RE: **Project#: PZSITE2025-00029 –** Conditional Use w New Construction
Parcel IDs: 2417-331-0010-0006- (3700 Okeechobee Rd.)

Thank you for reviewing the project referenced above. Giangrande Engineering & Planning is pleased to provide this response to the comments emailed June 4, 2026. Supporting documentation addressing each comment is supplied with this submittal. A summary of the comments and responses is provided below:

RE: **Project#: PZSITE2025-00029 –** Conditional Use w New Construction Parcel IDs: 2417-331-0010-0006- (3700 Okeechobee Rd.)

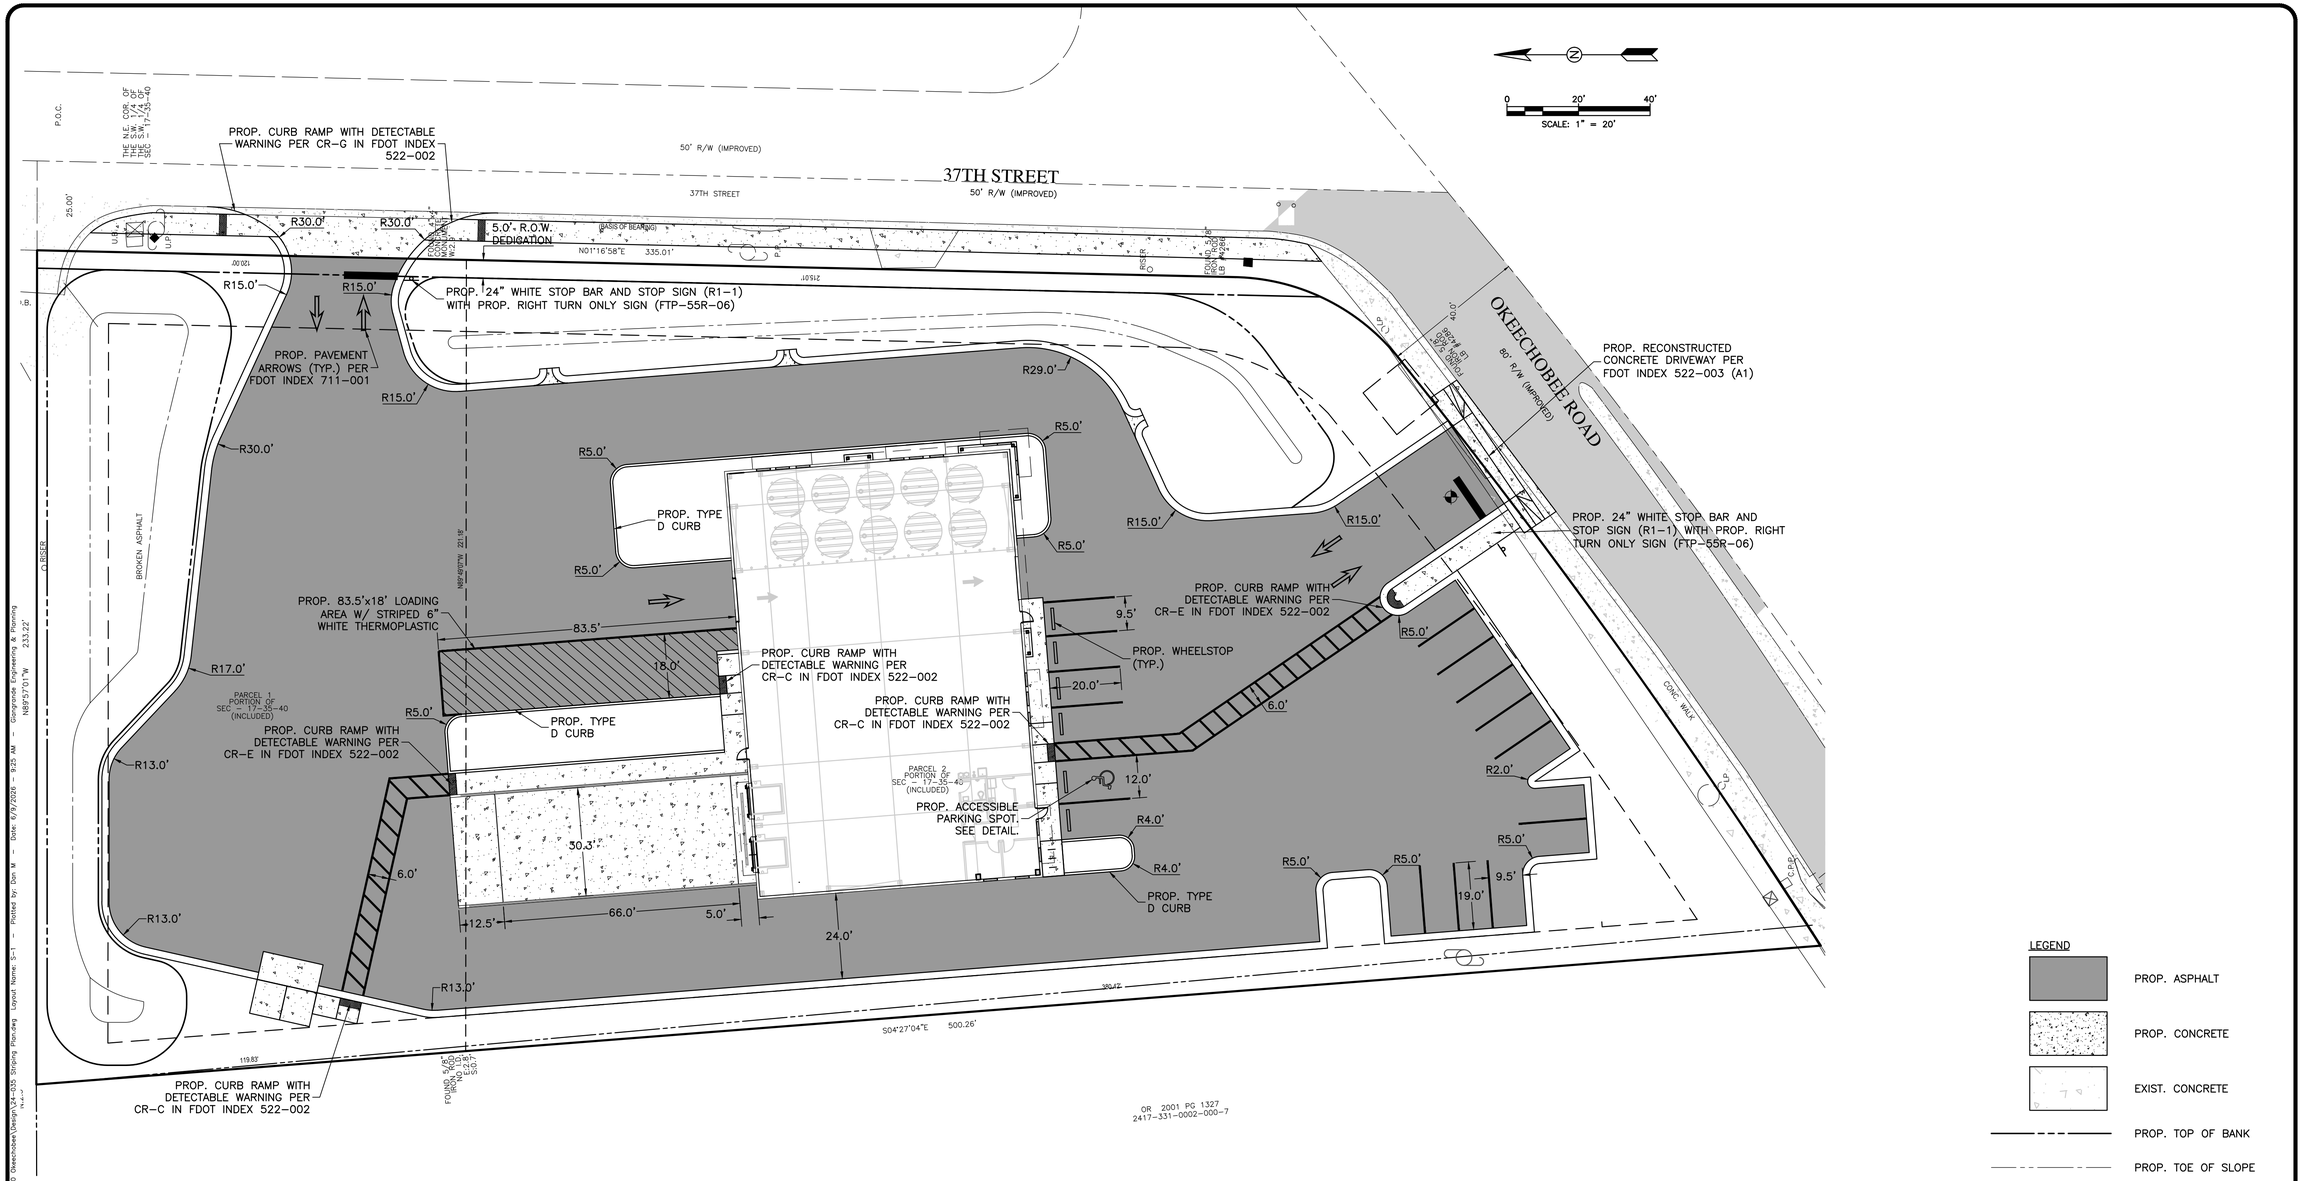
1. The revised Site Plan and Dumpster Detail show a sidewalk leading to the side of the double dumpster enclosure. The sidewalk dead-ends at the masonry wall of the dumpster with no access. Also, the dumpster detail shows a 8’ extended concrete apron from the dumpster enclosure, which is not represented on the plans. Please revise Site Plan or the dumpster detail to solve this issue.

Response: Find the revised site plan with this submittal showing a revised dumpster enclosure detail and the 8’ concrete apron.
